Commissioning Report Executive Summary

United States Diplomacy Center Owner's Project Requirements

Design Phase Commissioning Plan

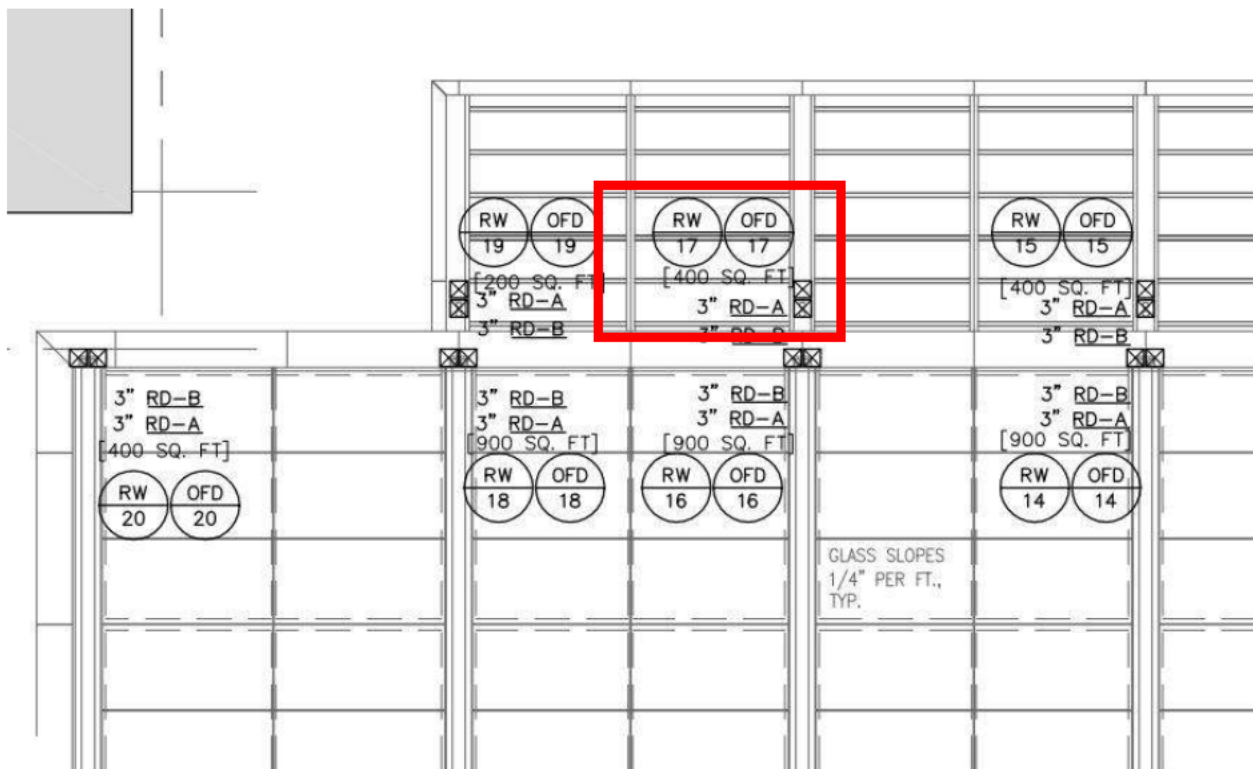
Evidence of a leak shown caused by roof leak from lower roof on north side of the facility, approximately 8 feet from west wall.

The area in the **Red** box shown in the plan view on following page is the general area of the leak.

Issue #37

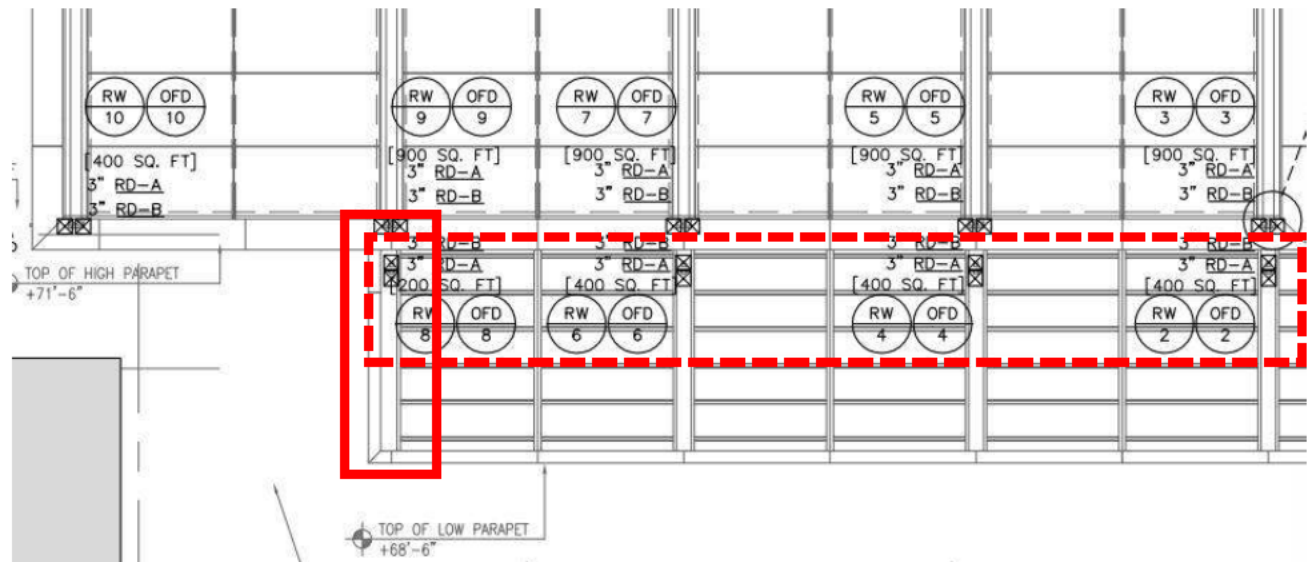
The western most lower roof drain on the south roof, outlined in Red below, failed allowing water to enter the building interior.

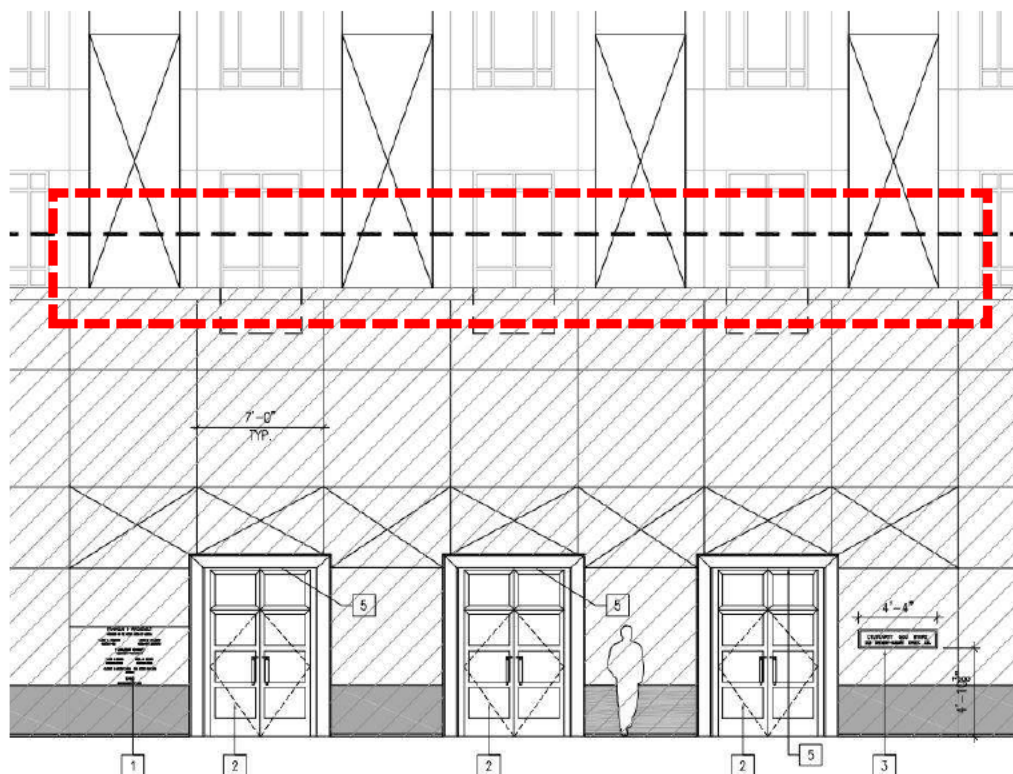
Images show spalled areas south elevation of the Harry S. Truman building adjacent USDC addition.

While contractors are currently on site, we recommend that these areas be repaired.

Issue #42

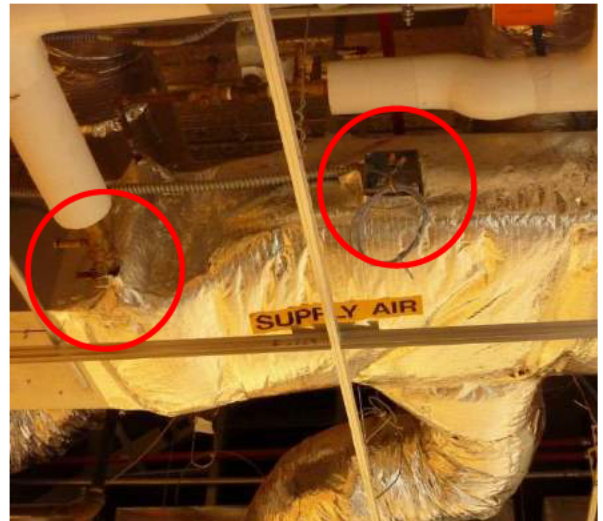
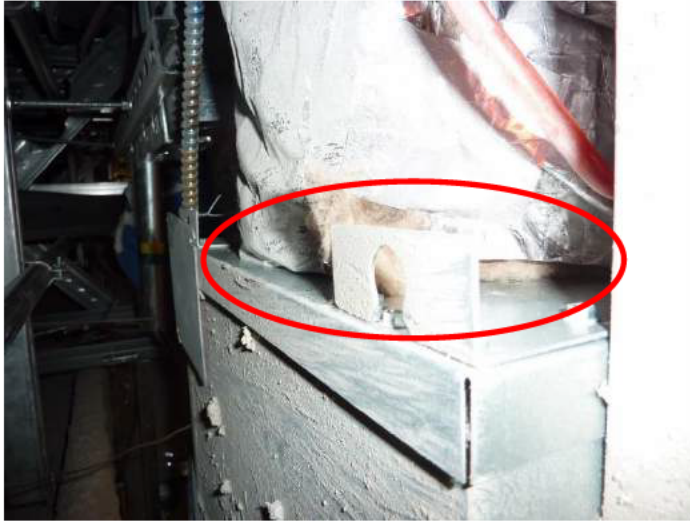
Vapor barrier discontinuities have been identified in a number of areas.

Seal vapor barrier at all penetrations, intersections, and terminations at assemblies.

Issue #42 ctd

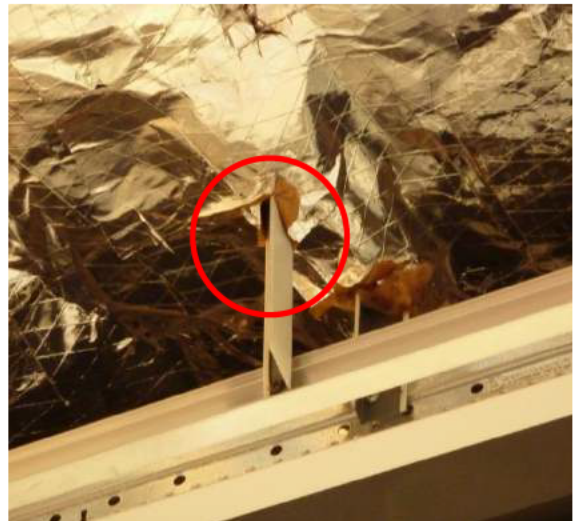
Vapor barrier discontinuities have been identified in a number of areas.

Seal vapor barrier at all penetrations, intersections, and terminations at assemblies.

Issue #44

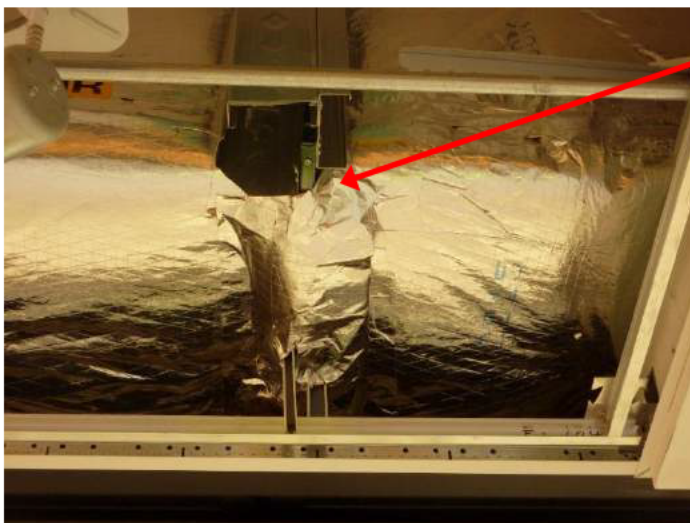
A number of duct sections have not been installed fully extended and have an un-necessarily tight bend radius. This condition causes a need for increased fan power in order to supply airflow, increasing energy consumption by the HVAC system. Install flex duct in accordance with ADC Flexible Duct Performance & Installation Standards and ASHRAE Handbook of Fundamentals 2013 to minimize pressure drop and flow restrictions.

Duct section is compressed by adjacent assembly. Reducing insulation effectiveness.

Issue # 5

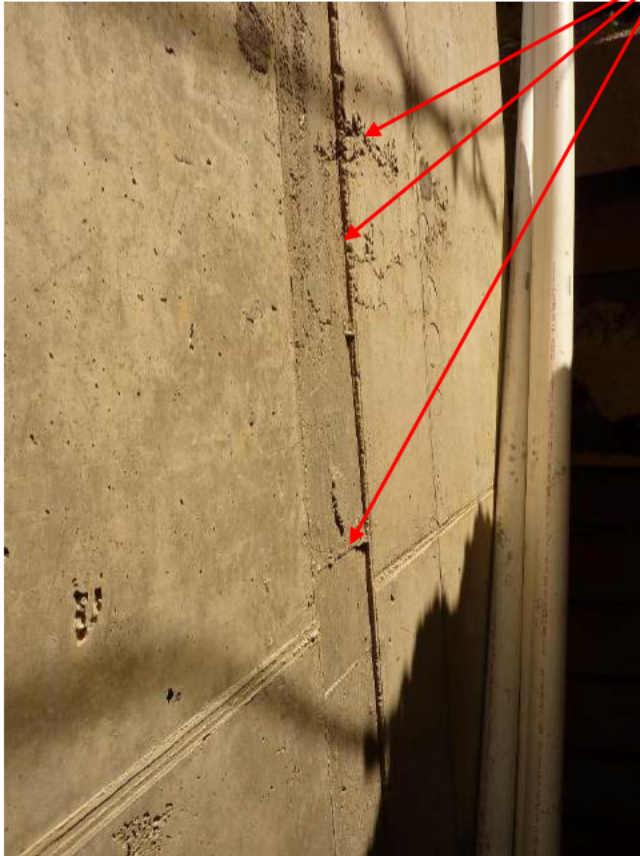
Southeast corner requiring patching to provide a smooth surface prior to application of Bituthane membrane. Patch mortar, or grout and trowel smooth in accordance with manufacturer's installation instructions.

Issue #22

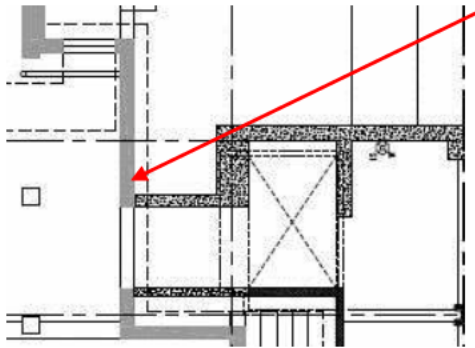
Additional sections of ductwork were observed during the site visit as not being protected as required by specification.

Observations:**Issue #24**

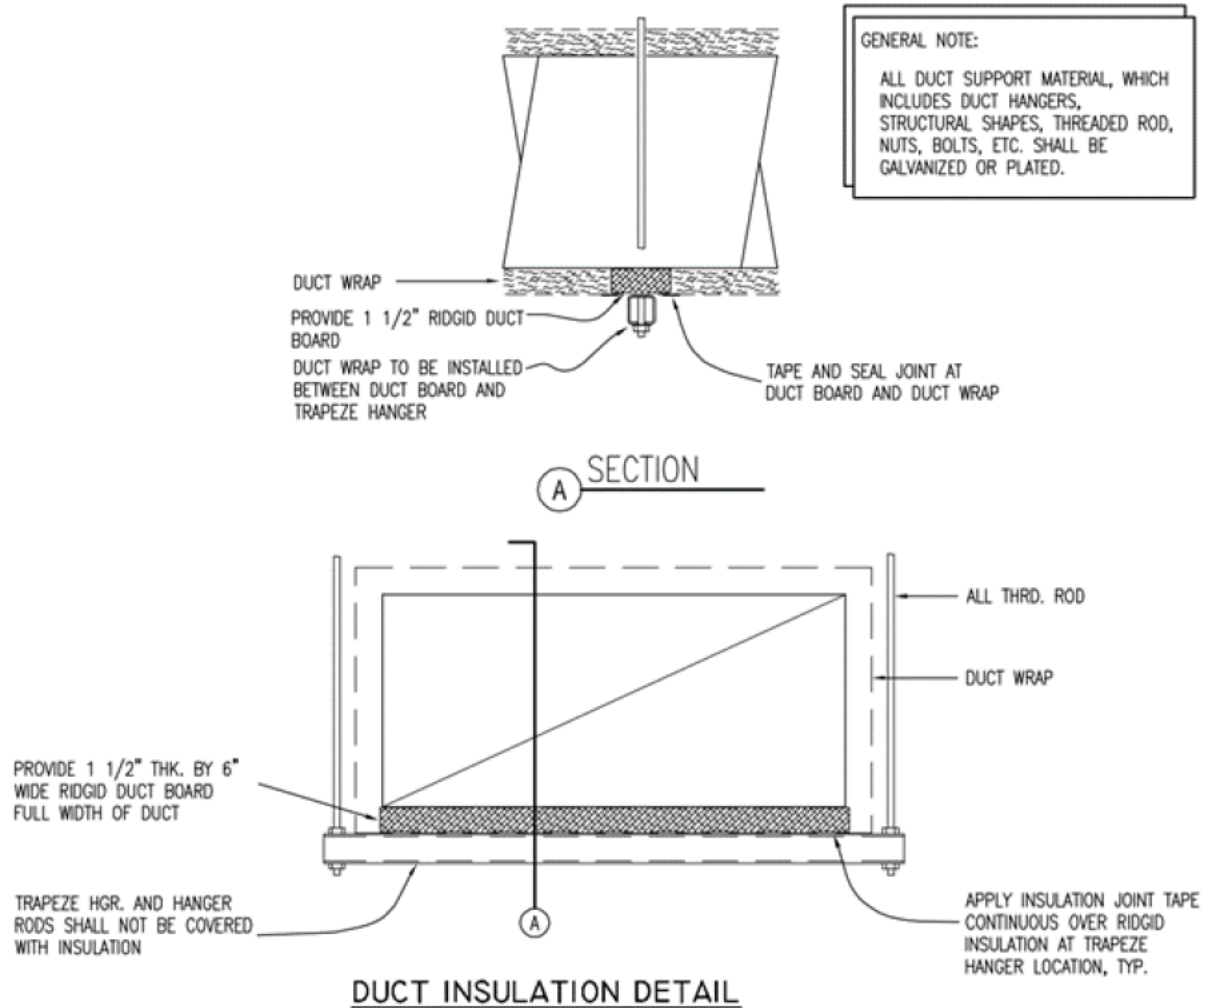
Incorrect installation of insulation of HVAC ducts were observed throughout. Duct hangers cannot be insulated around. Integrity of insulation and vapor barrier must be maintained.

Typical condition observed throughout requiring correction.

Issue #26

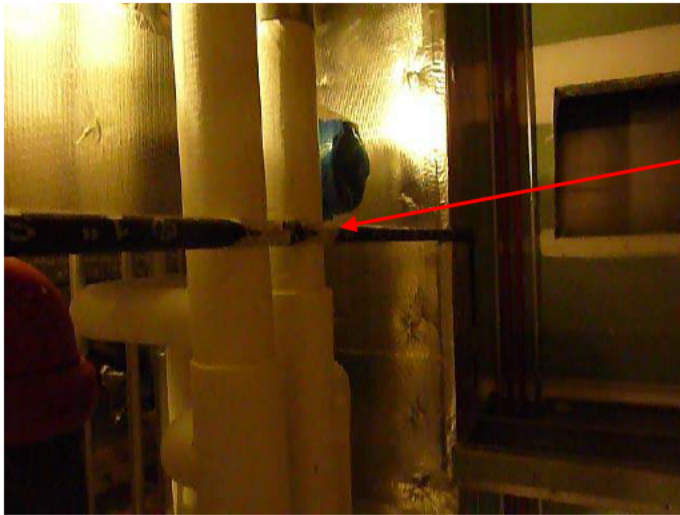
Breaches in vapor barrier observed throughout. All breaches must be sealed.

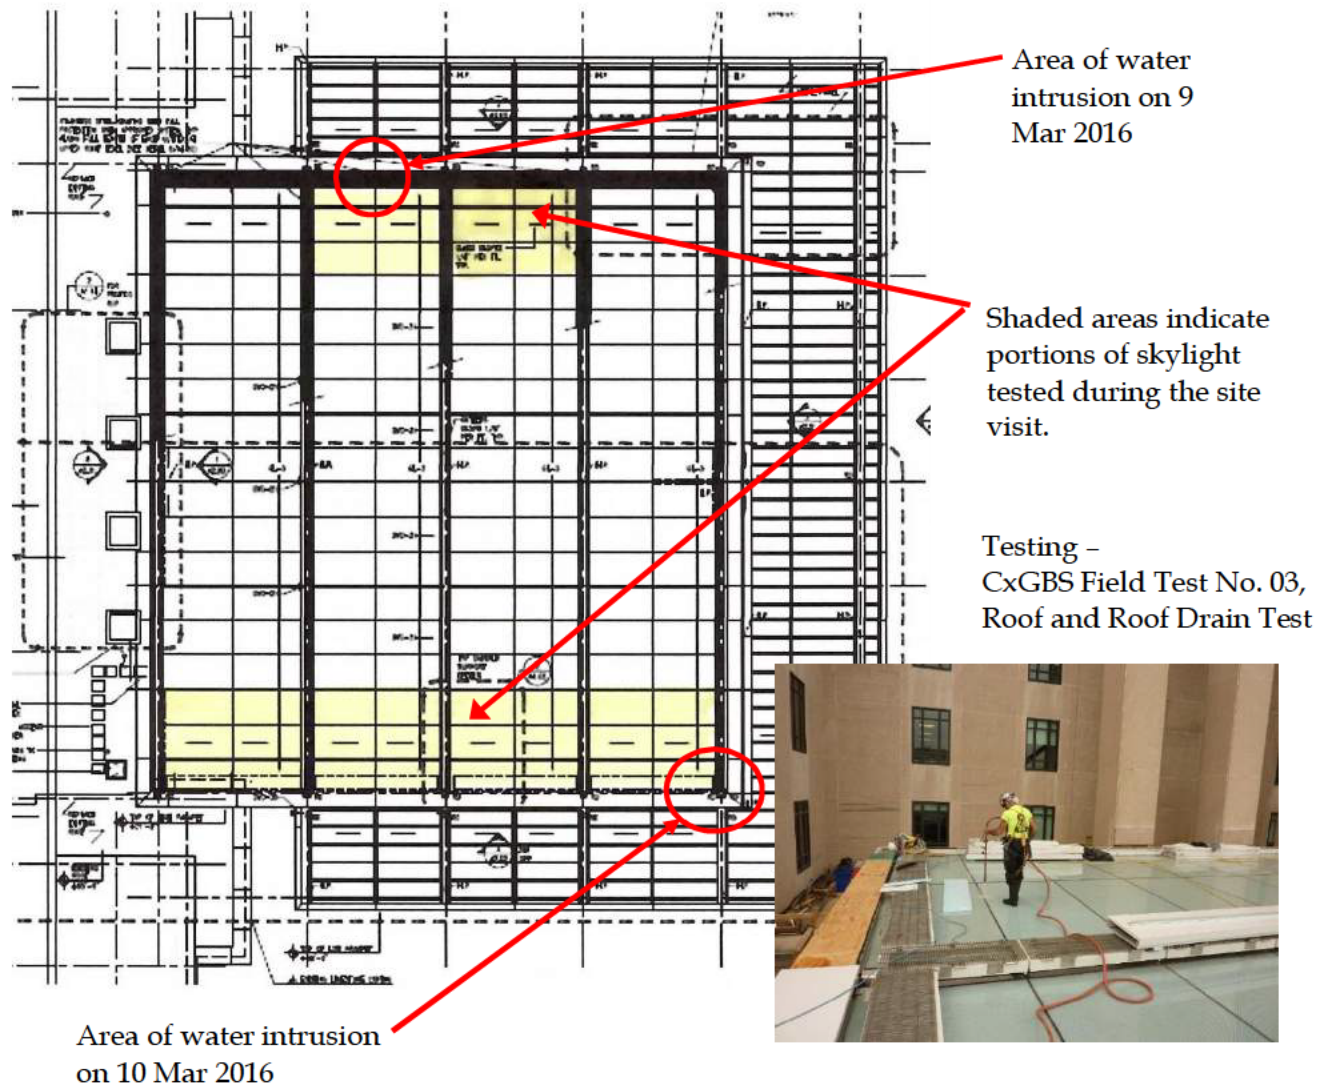
The 1st area of water intrusion through the upper roof assembly was observed at the intersection between the skylight and parapet along the north parapet. Heery, GCC and FN reported that the assembly at the intersection of the skylight and parapet was not complete. Based on this information CxGBS limited testing to the skylight assembly and upper roof gutters only. However, based on detailed examination of the FN shop drawings and onsite observations there appears to be a breach or discontinuity in the waterproofing membrane that transitions from the gypsum substrate to the gutter (See Issue# 24). On the 2nd day of testing water intrusion was also observed on the southeast corner of the skylight. The leak is determined to be coming from a breach in the air barrier (See Issue 25). Further investigation by FN is required to determine the exact path of water intrusion.

FN Detail 404

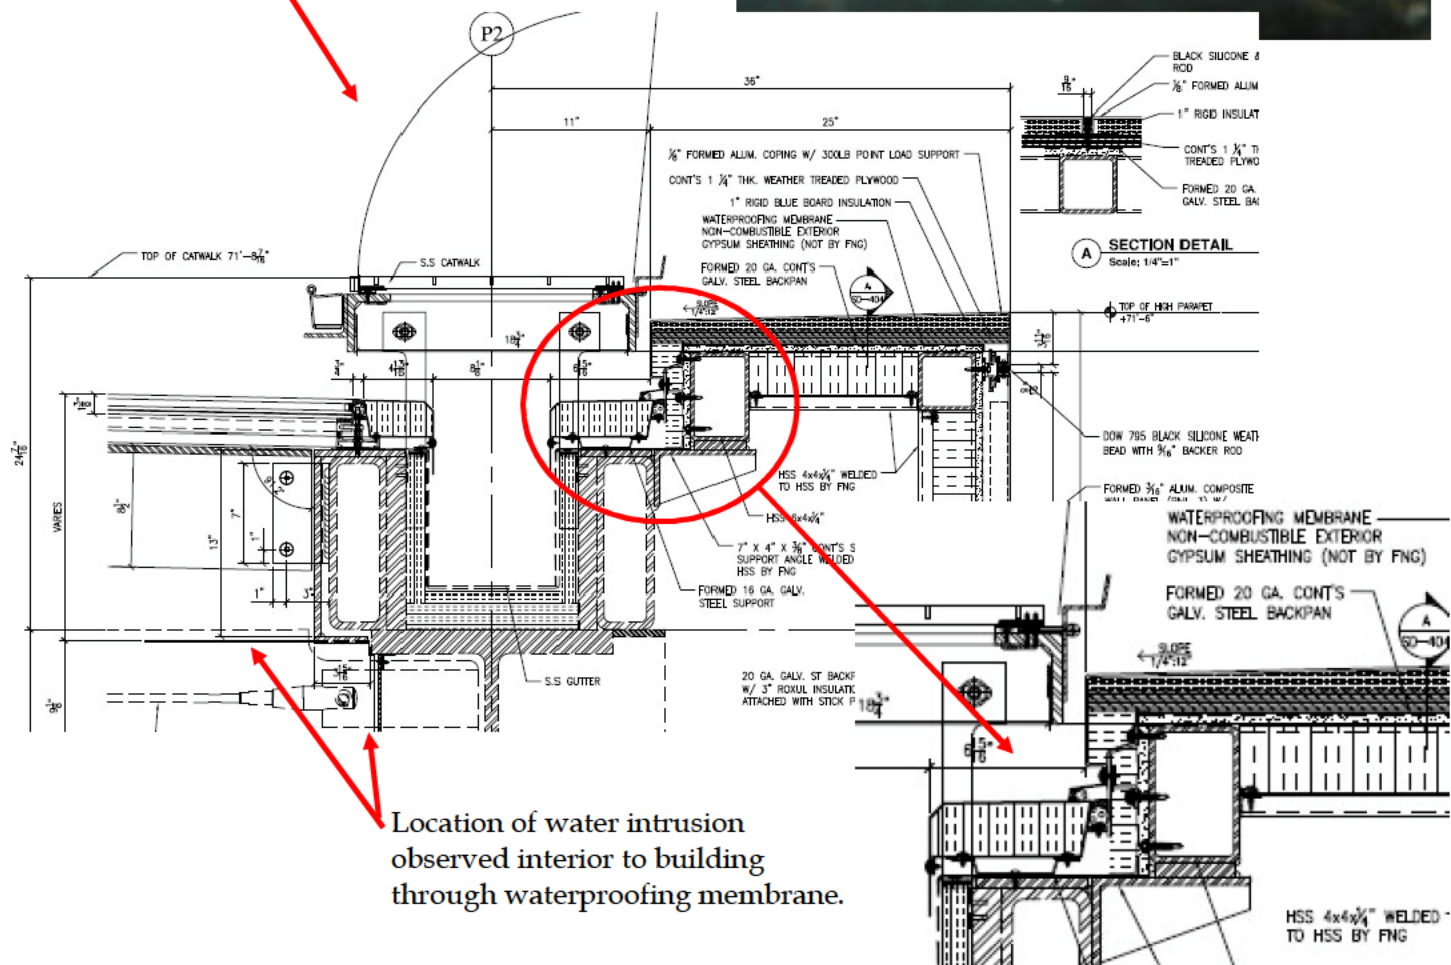
Issue #24

Locations of water observed in interior below north skylight parapet wall

FN Detail SD-401

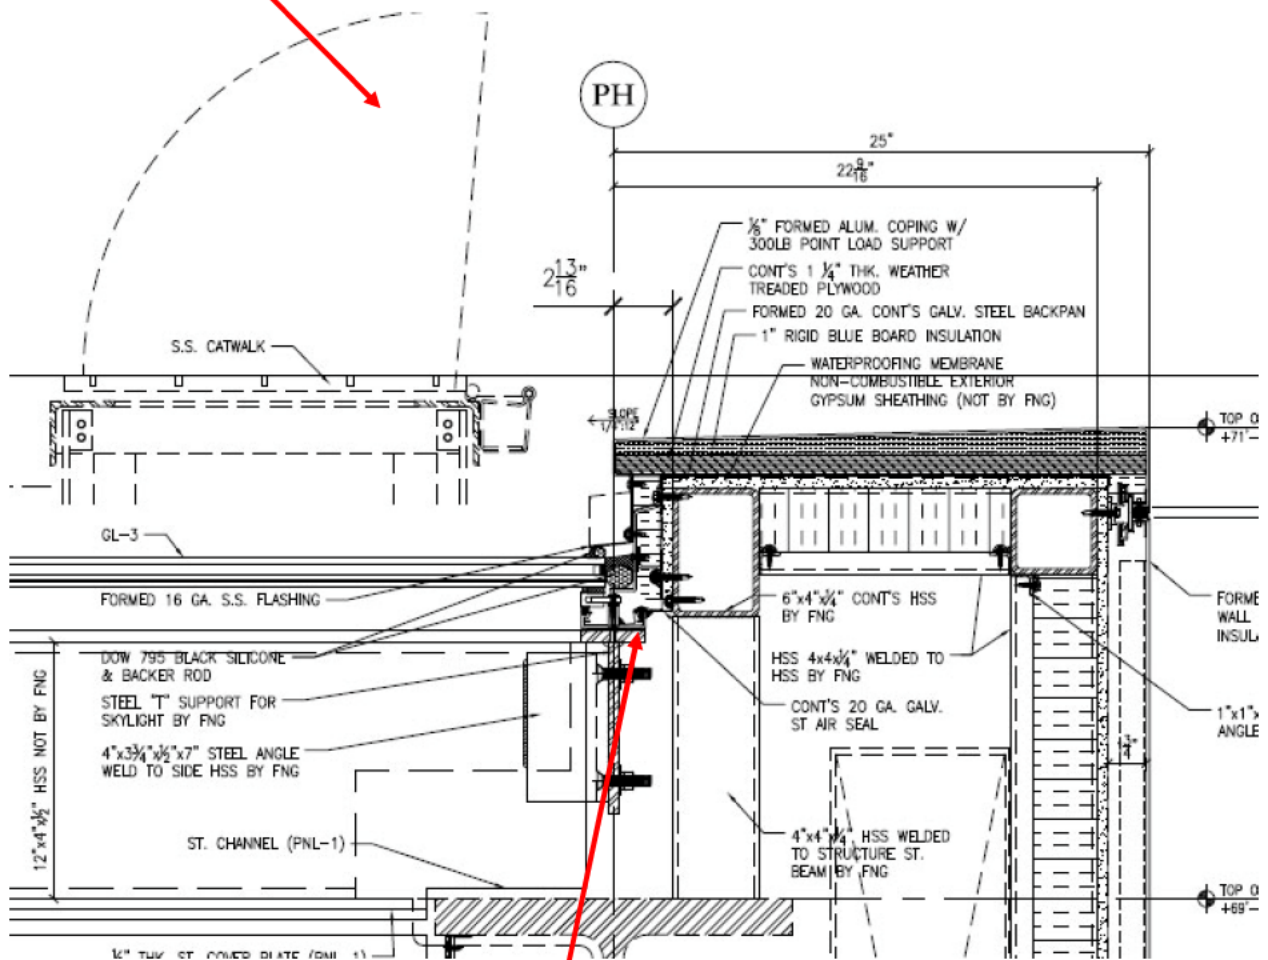
Location of water intrusion
observed below skylight southeast
corner.

Water observed leaking
from air barrier FN Detail
SD-401

Issue #27

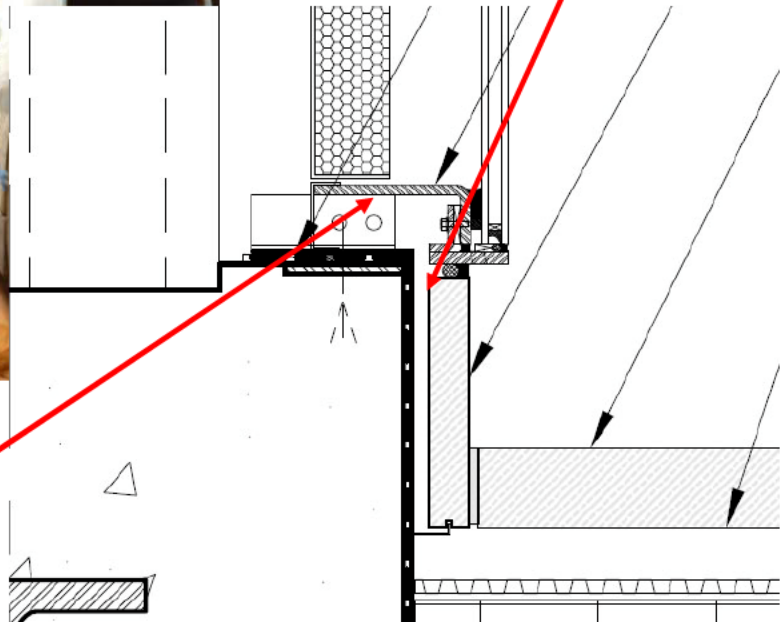
Multiple breaches observed in waterproofing along South Foundation requiring correction.
